Official Recall Notification: U.S. Federal Boat Safety Act

Possible Incorrect Routing Causing Pinched or Chafed Wires on 3.0 MPI Engine Harness

Models Covered	Serial Numbers
3.0 MPI Models	1A072812-1A650359

Incorrect routing of harness—behind bracket

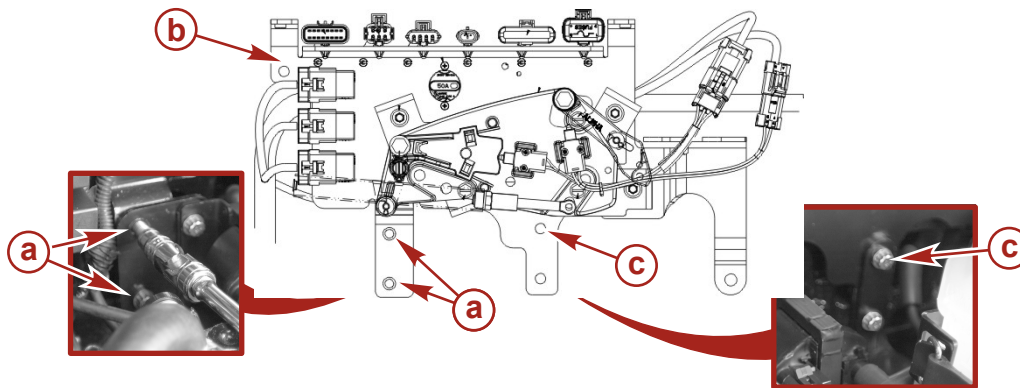
Mercury MerCruiser has received some customer complaints concerning starters that do not operate or crank the engine. This problem may be caused by a blown 90-amp fuse (at the starter solenoid) or a 50-amp circuit breaker that has tripped. This interruption of electrical current may be caused by incorrect routing of a portion of the engine wiring harness. A wire that is routed below the shift plate mounting bracket can become pinched or chafed through the insulation, causing a direct short circuit to ground, which could create an ignition source. Either the 90-amp fuse or the 50-amp circuit breaker may trip first. If the 90-amp fuse blows first, there is no further opportunity for arcing. If the 50-amp circuit breaker is tripped first, an opportunity for arcing exists until the battery is disconnected.

2. Inspect the harness below the shift plate mounting bracket for incorrect routing.

3. If the harness is routed incorrectly and pinched behind the shift plate mounting bracket, loosen the mounting bracket screws identified below.

48262

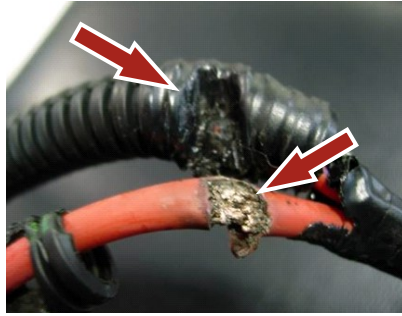
5. Carefully inspect the harness at the area of the pinch.
6. If the harness was pinched or scuffed, but the insulation appears to be intact:
 - a. Securely tape the pinched area of the harness with at least two layers of electrical tape.
 - b. Route the wiring harness to match the routing of the harness in the figure in step 8.

Example of damaged insulation and bare wire

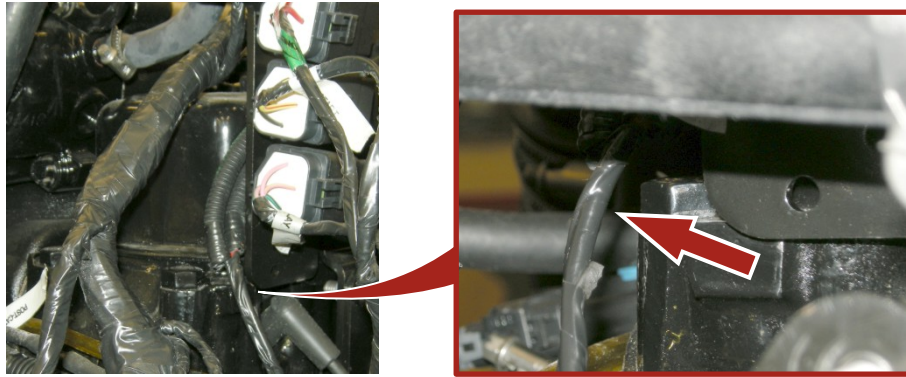
7. If the harness was pinched and the insulation is damaged or revealing bare copper wire:

- a. Replace the complete engine wiring harness. Order the part number listed in **Replacement Parts**.
 - b. Route the wiring harness to match the routing of the harness in step 8.
8. For a harness that shows no damage, prevent damage to the harness by ensuring that the harness is not routed behind the bracket where it could be pinched or chafed through the insulation.
